## RFP 2017-02 Wakulla Office Remodel - Questions & Answers

# A1.1

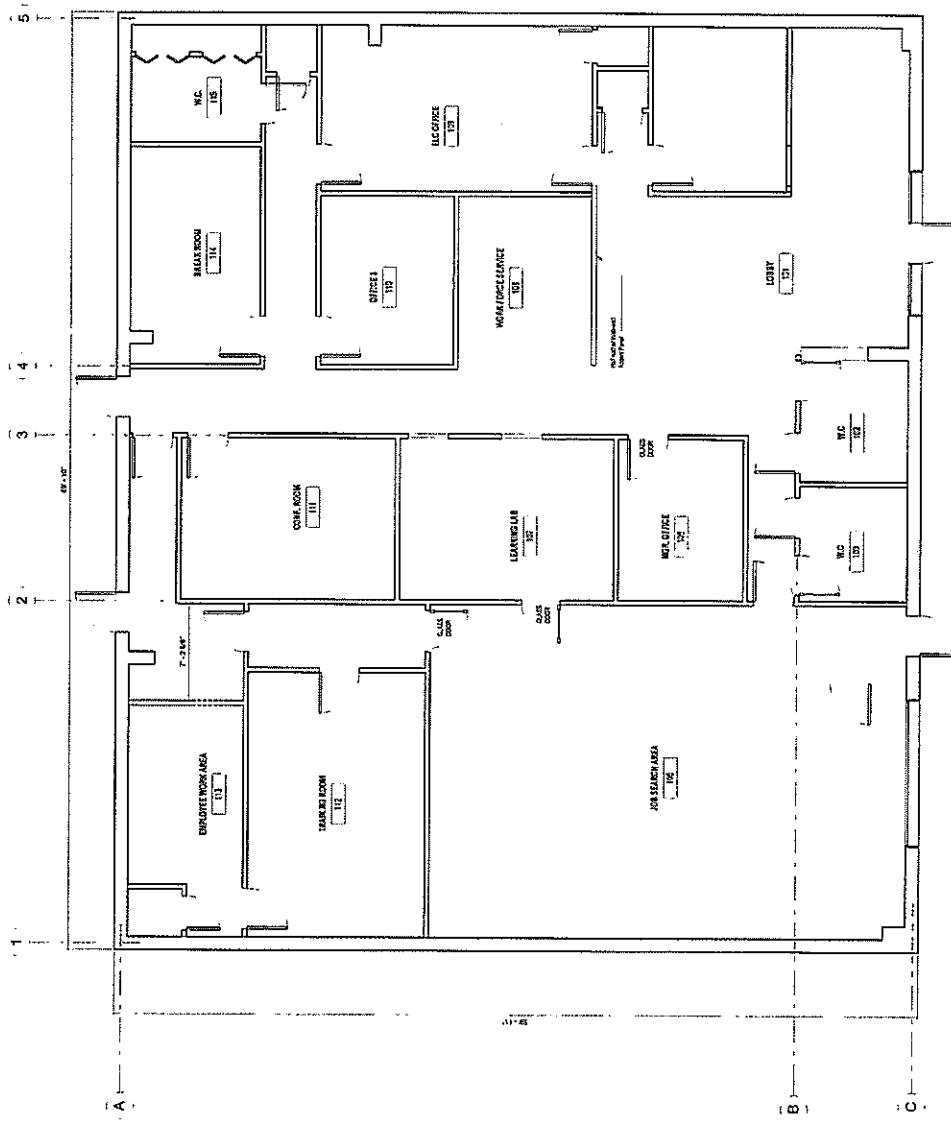
11. On Page 1 of the RFP item 11 says; “Doors to offices to have glass inserts as indicated on drawing.” Where are doors needing lights shown? Page 4 of the RFP is pixelated and the writing can’t be interpreted. Are the glass doors in the Learning Lab? If so what dimensions is required

for the door lights and what type of glass is required? **Attached plan sheet from Barnett Fronczak has door schedule that identifies doors.**

1 Demolition Plan  
D1.1 1/8" = 1'-0"

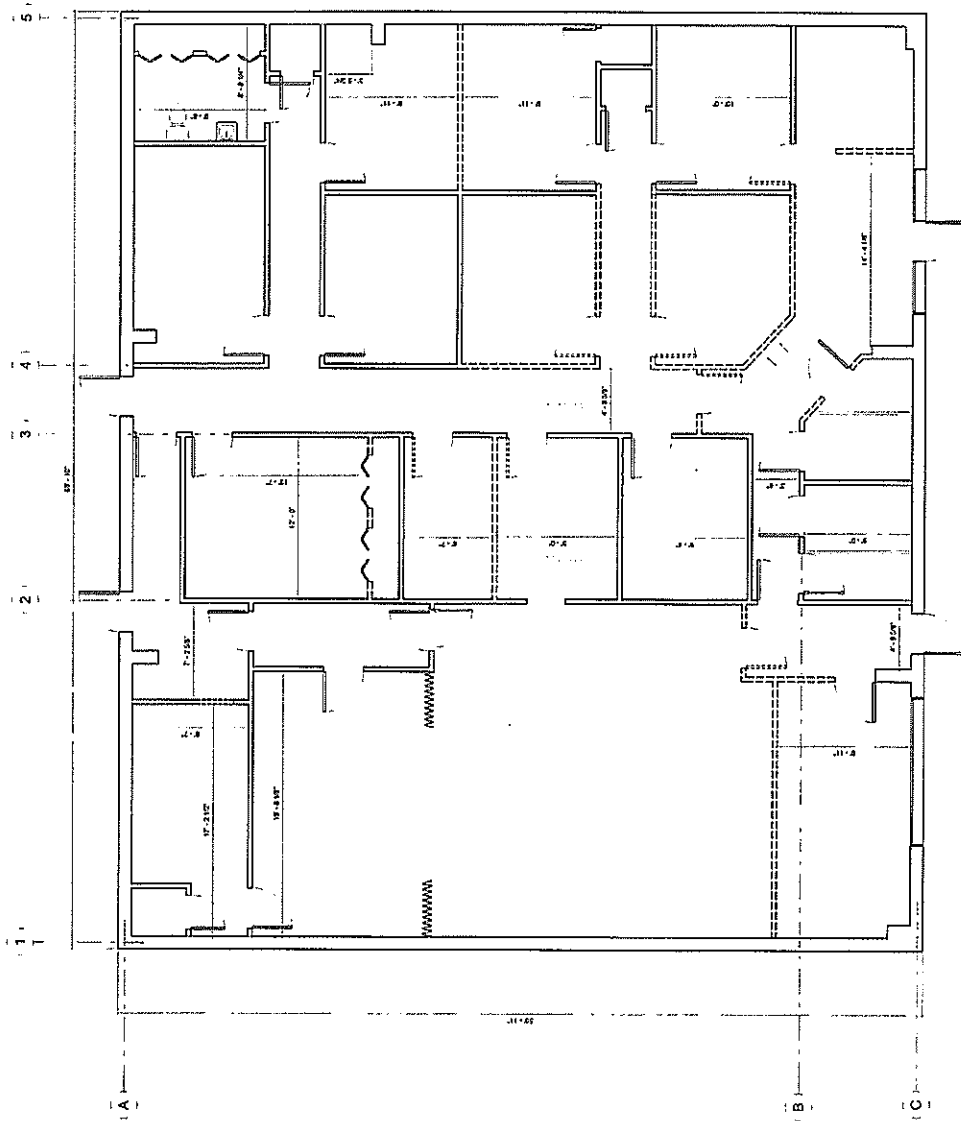
2. On Page 1 of the RFP item 1 says; “LED up lighting over open cubicle area – two rows”.
  - a. No lighting plan is included in the RFP showing cubicles or lighting layout. Is this design documentation to be provided? **Please refer to page D1.1 of the attached plans.**
